TO: Mayor Tommy Allegood, City of Acworth
ATTN TO: Alex Almodovar, Development Director, City of Acworth
FROM: Mike Alexander, Director, ARC Center for Livable Communities
RE: Development of Regional Impact (DRI) Review

Name of Proposal: The Logan DRI 3775

Description: A DRI review of a proposal to construct a mixed-use development on a previously developed 16 acre site at 5200 Cherokee Street in the city of Acworth in Cobb County. The project includes 208,980 SF of medical office space, a 180 room hotel, 500 multi-family units, 15,188 SF of restaurant space, and 11,132 SF of retail space.

SITE PLAN

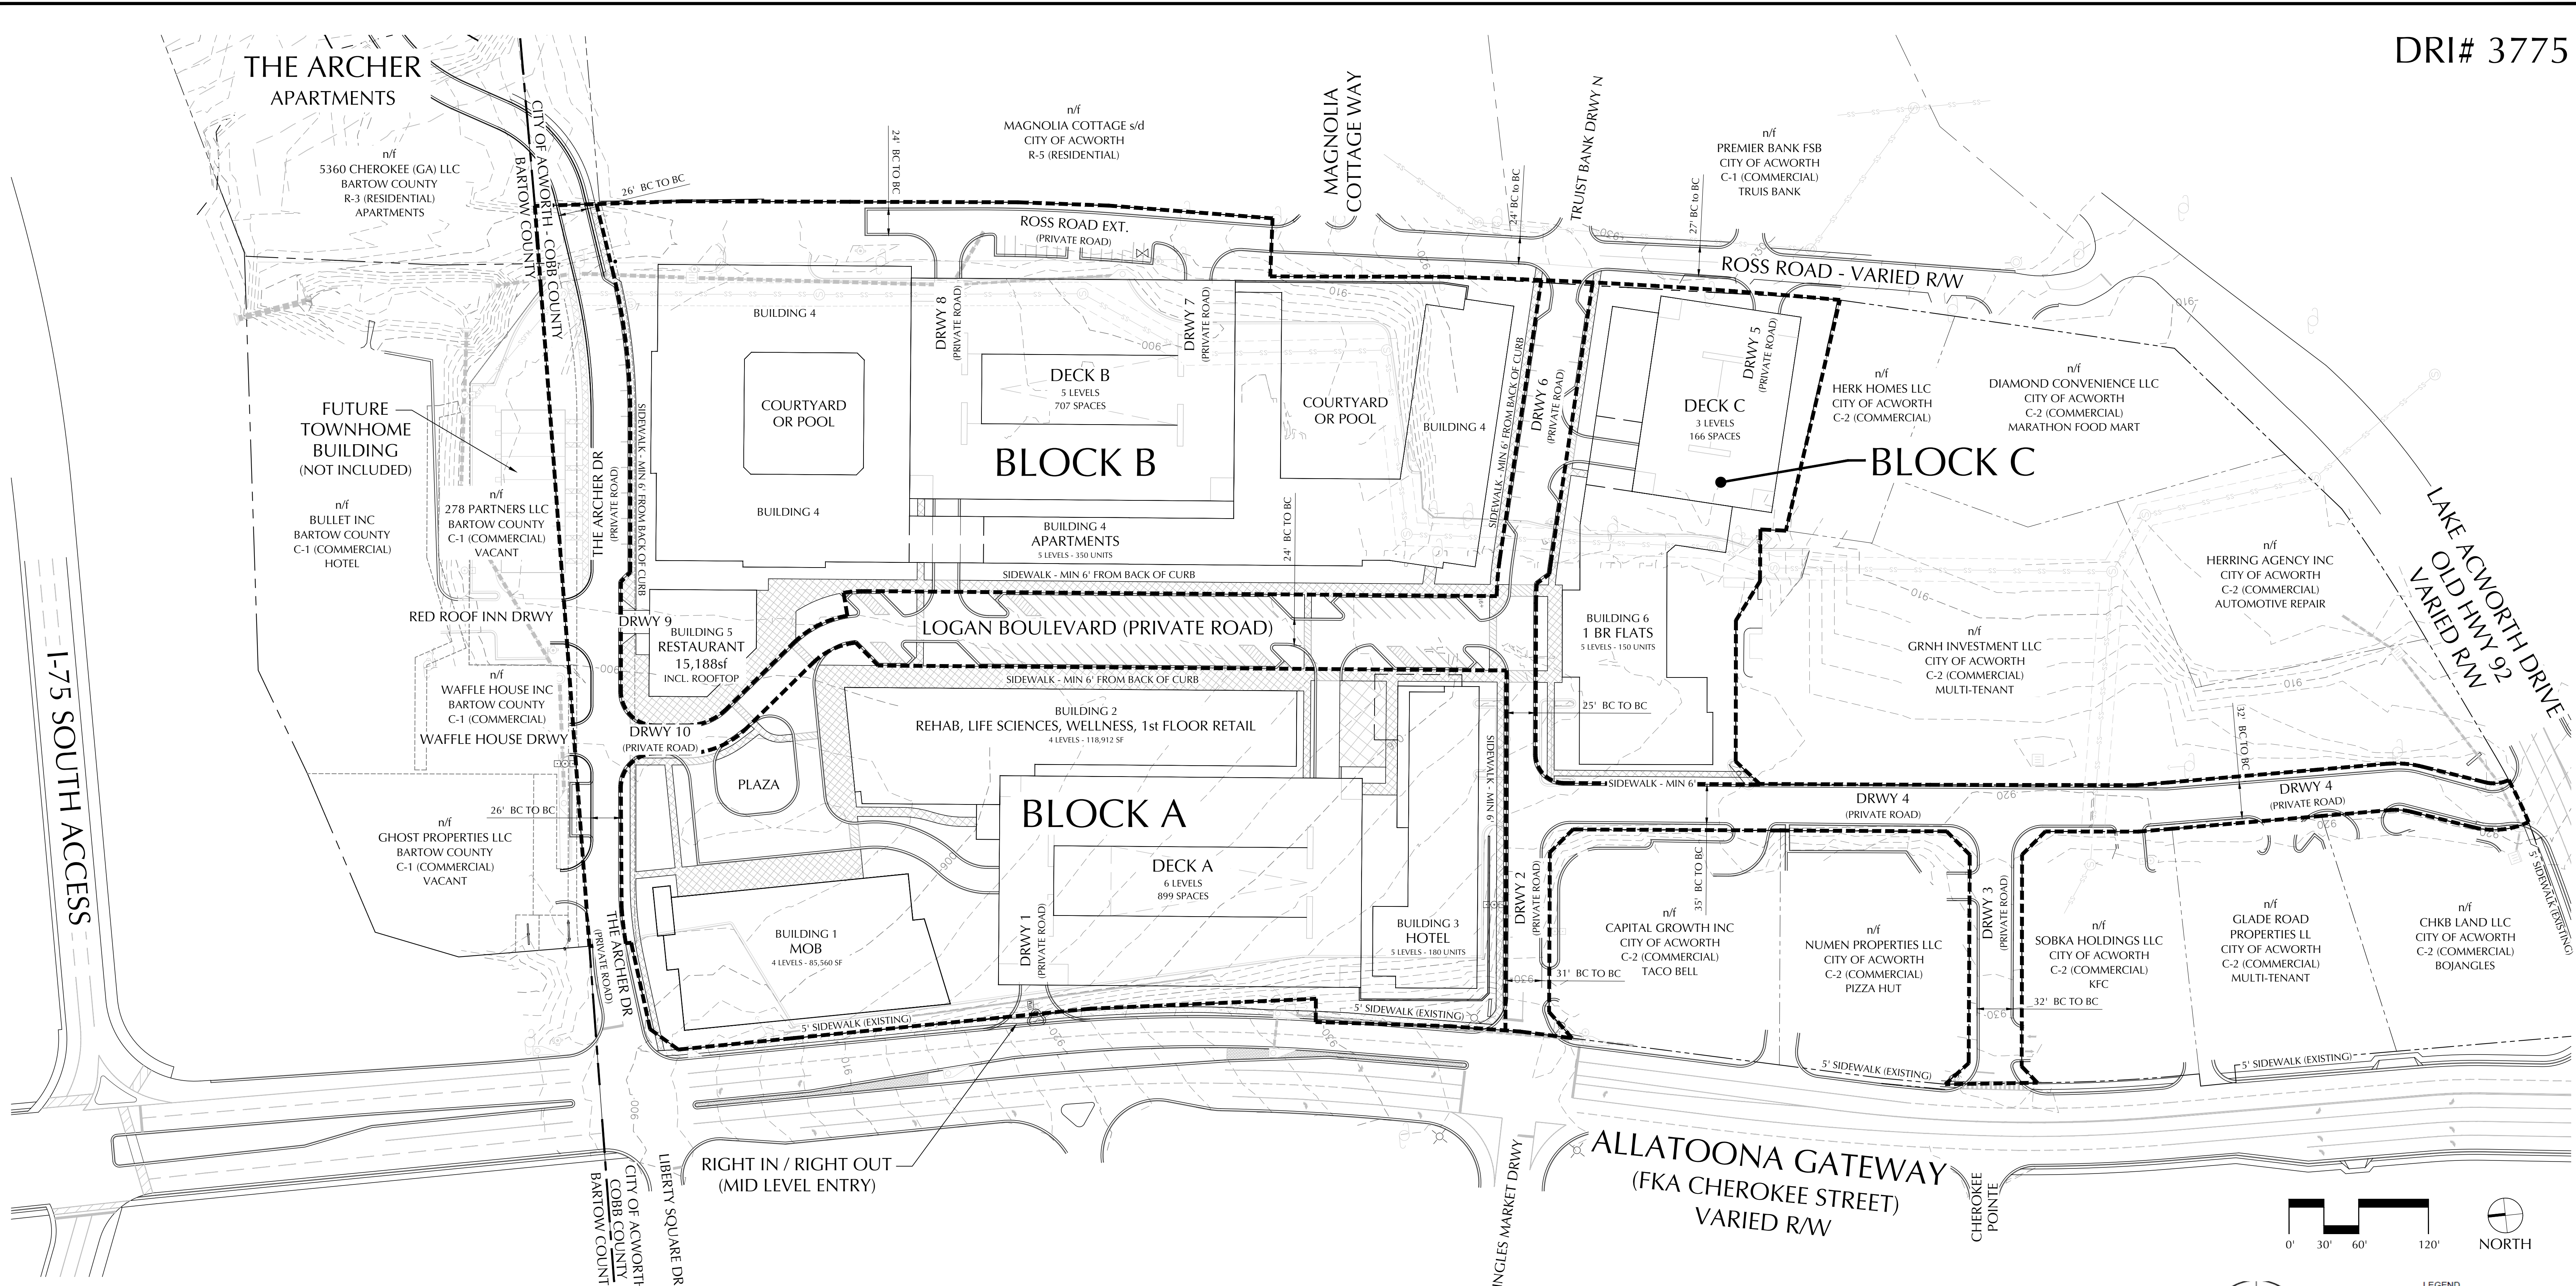
The project's urban design falls well short of regional placemaking goals and misses the rare opportunity to create a welcoming and memorable gateway from I-75 to historic downtown Acworth in a way that extends some of the downtown character to the north. Ideally the design could be revisited to create appealing

architecture along the whole Cherokee Street frontage with active ground floor uses or jewel box retail/café uses fronting a very wide sidewalk with outdoor café space and a pocket park.

The project's urban design falls well short of regional placemaking goals and misses the rare opportunity to create a welcoming and memorable gateway from I-75 to historic downtown Acworth in a way that extends some of the character of the historic downtown just about a mile away. The proposed parking deck fronting Cherokee and the mid-block driveway needed to access it is a particular concern. This driveway splits what should be a continuous walkable segment fronting Cherokee Street. Ideally the design could be revisited, as discussed at the Pre-Review meeting, to create appealing architecture along the whole Cherokee Street frontage with active ground floor or jewel box retail/café uses fronting a very wide sidewalk with outdoor café space and a pocket park. The City's Comprehensive Plan strongly embraces this concept and provides numerous images of design examples that would work well.

The surrounding pedestrian and bicycle infrastructure is very limited and should be substantially strengthened to provide a safe and inviting pedestrian and bicycle linkage to downtown. Guests at the 180 room hotel and residents of the 500 apartments hotel could easily bike or even walk the one mile to downtown if an appropriate route is provided. This would lessen vehicular trips and provide customers for downtown businesses. Appropriate routes and crosswalks are also needed at the Logan Place/Cherokee Street intersection so that the many residents and hotel guests can cross Cherokee Street to access the

grocery store. A signalized intersection with safe wide crosswalks is the appropriate solution at this location; the roundabout which appears to be shown is not recommended as it prioritizes continuous vehicular movement over pedestrian comfort and ease of access.
